Application reference: EPR/VP3829SK/A001
Operator: United Utilities Water Limited
Facility: Burnley WwTW Sludge Treatment Facility

In response to the questions received on 11/12/2023 on the above permit application, please refer to the additional information provided in blue text.

Figure 8 Burnley STC Modelled Point of Discharge for Screened Sludge Tank

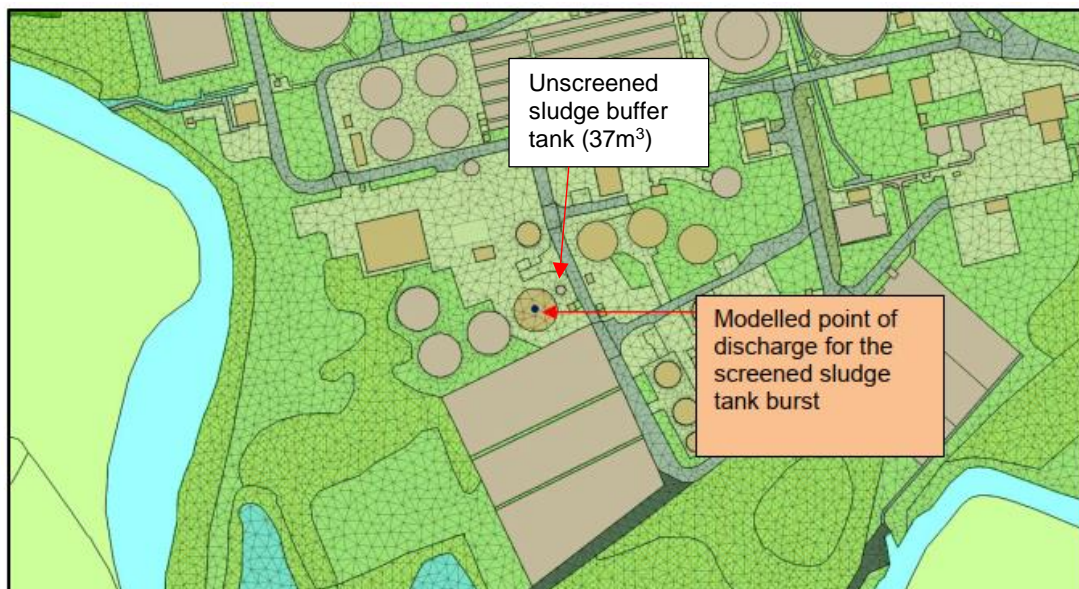
- 3) Include the unscreened sludge buffer tank in all containment tank tables. The 37m³ tank has not been included in the tank capacity table in the BAT Improvement Programme document or in Table 1: Assets table in the secondary containment report.

The unscreened sludge buffer tank was unfortunately missed from the secondary containment modelling assessment. This tank is situated adjacent to the screened sludge tank which has a capacity of 2,500m³. The screened sludge tank is in Group 2 of the tank grouping for the spill containment modelling. An inflow file of 2,750m³ was created for Group 2 (110% of 2,500m³ tank volume) and applied to the model simulation. Given the comparatively small capacity of the unscreened sludge buffer tank (37m³), there is a high degree of confidence that the proposed containment volume and wall height in this area would be adequate to contain a catastrophic release from the unscreened sludge buffer tank.

The containment solution based on the October 2022 modelling assessment (presented in the Improvement Programme) is conceptual, and design work is ongoing to refine this. United Utilities are committed to meeting BAT, or justified BAT equivalent, for the final containment solution at the Burnley sludge treatment facility.

The position of the unscreened sludge buffer tank in relation to tank Group 2 (screened sludge tank) is shown on the figure below extracted from the containment modelling assessment report. Also see Appendix E of the Application Support Document for tank positioning.

Figure 16 Burnley STC Modelled Point of Discharge for Thickening Centrate Storage Tank

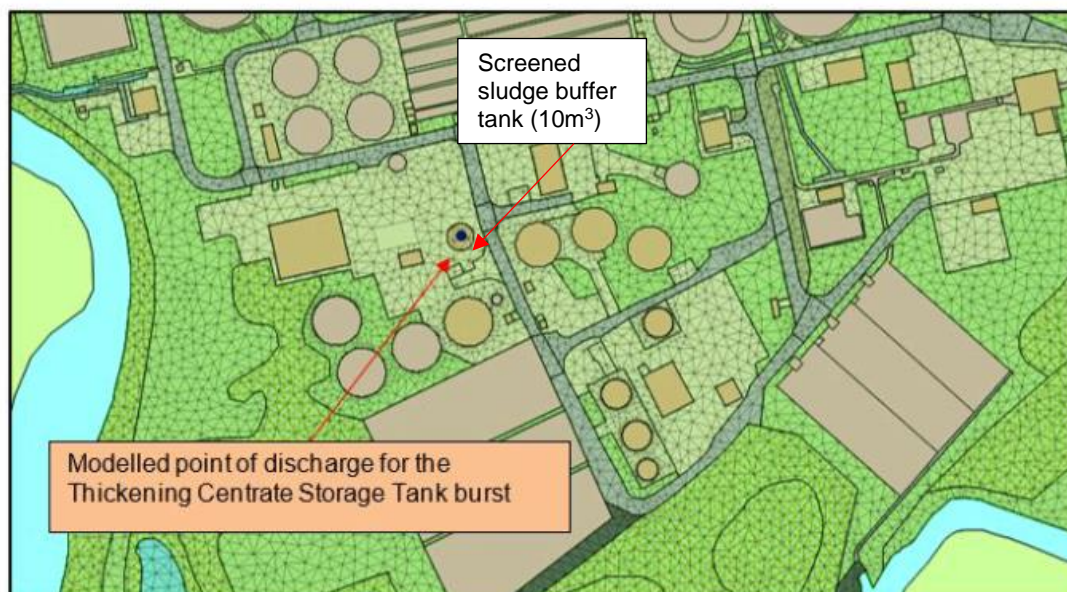
- 4) Include the 10m³ screened sludge buffer tank in Table 1: Assets table in the secondary containment report.

The screened sludge buffer tank was unfortunately missed from the secondary containment modelling assessment. This tank is situated adjacent to the thickening centrate (buffer) storage tank which has a capacity of 200m³. The thickening centrate tank is in Group 6 of the tank grouping for the spill containment modelling. An inflow file of 217m³ was created for Group 2 (110% of 200m³ tank volume) and applied to the model simulation. Given the comparatively small capacity of the unscreened sludge buffer tank (10m³), there is a high degree of confidence that the proposed containment volume and wall height in this area would be adequate to contain a catastrophic release from the screened sludge buffer tank.

The containment solution based on the October 2022 modelling assessment (presented in the Improvement Programme) is conceptual, and design work is ongoing to refine this. United Utilities are committed to meeting BAT, or justified BAT equivalent, for the final containment solution at the Burnley sludge treatment facility.

The position of the screened sludge buffer tank in relation to tank Group 6 (thickening centrate tank) is shown on the figure below extracted from the containment modelling assessment report. Also see Appendix E of the Application Support Document for tank positioning.
